FM STEREO/FM-AM RECEIVER

STR-6065

SUPPLEMENT

No. 2
April, 1973

POWER AMP SECTION

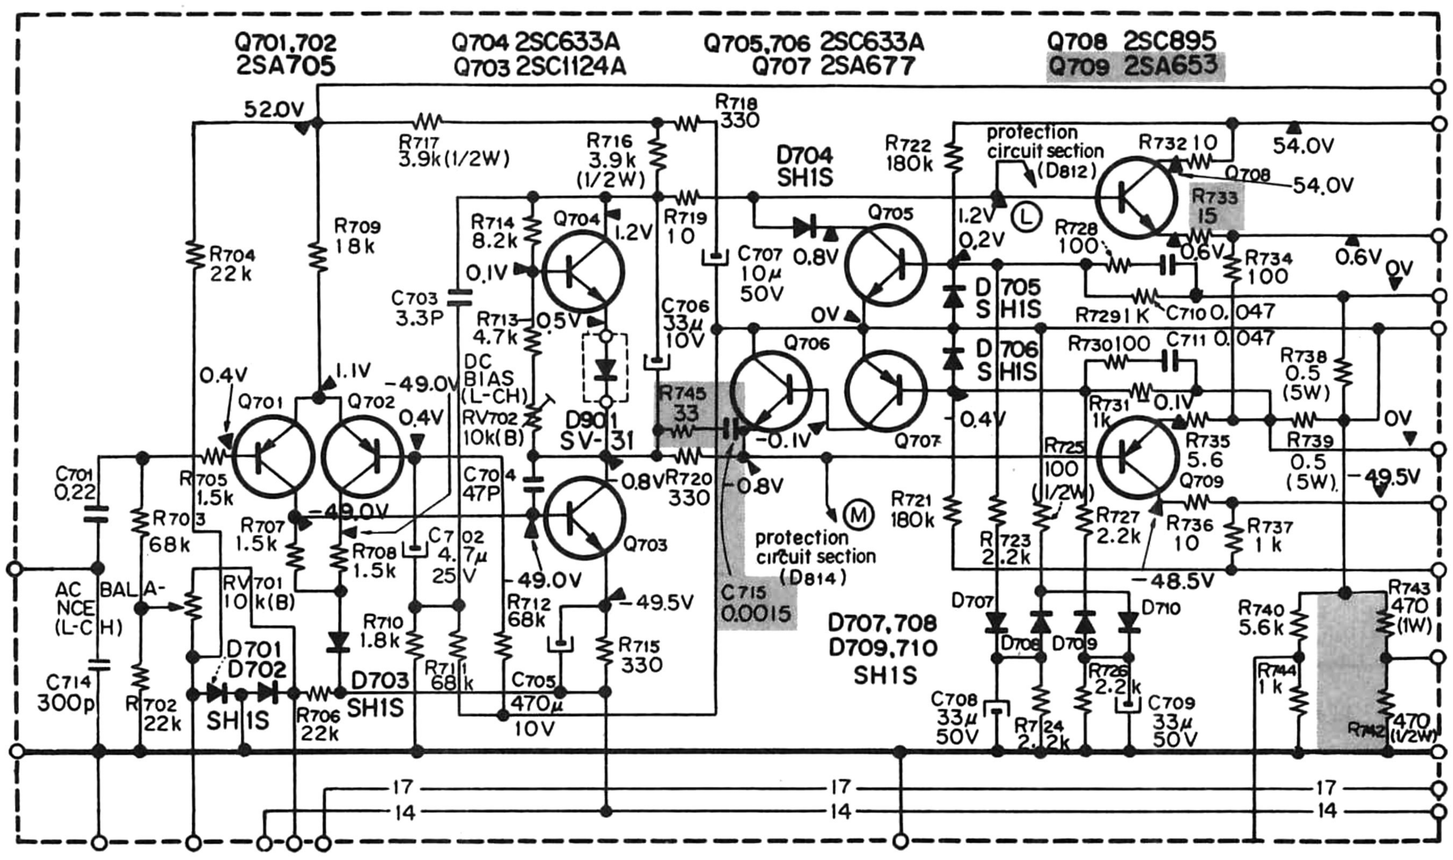
The power amplifier board has been modified because transistors, Q709 and Q759, in driver stage, changed from 2SA527 to 2SA653.

Ref. No.	*Former Part No./Value*	*New Part No./Value*	*Remarks*
Q709 (Q759)	transistor, 2SA527	2SA653	changed
C712 (C762)	1-105-679-12 0.033 ±10% 50V mylar	----------	deleted
C715 (C716)	----------	1-105-503-12 0.0015 ±5% 200V mylar	added
R733 (R783)	1-242-619 5.6 ±5% ¼W carbon	1-242-629-11 15 ±5% ¼W carbon	changed
R741 (R791)	1-202-525 10 ±5% ½W composition	----------	deleted
R745 (R795)	----------	1-244-637-11 33 ±5% ¼W carbon	added
